Proposal for Supplement [8] to the 00 series of amendments of Regulation No. 99

I. Proposal

"ANNEX 3
EXAMPLE OF THE ARRANGEMENT OF THE APPROVAL MARK
(see paragraph 2.4.4)

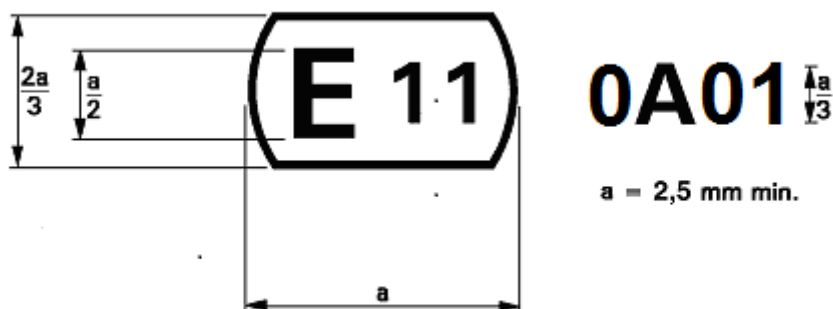
Annex 3, amend to read:

The above approval mark affixed to a gas-discharge light source indicates that the light source has been approved in the United Kingdom (E11) under the approval code 0A01. The first character of the approval code indicates that the approval was granted in accordance with the requirements of Regulation No 99 in its original form."

In addition the reference in Annex 3 should be corrected and read "(see paragraph 2.4.4)" instead of "(see paragraph 2.4.3)".
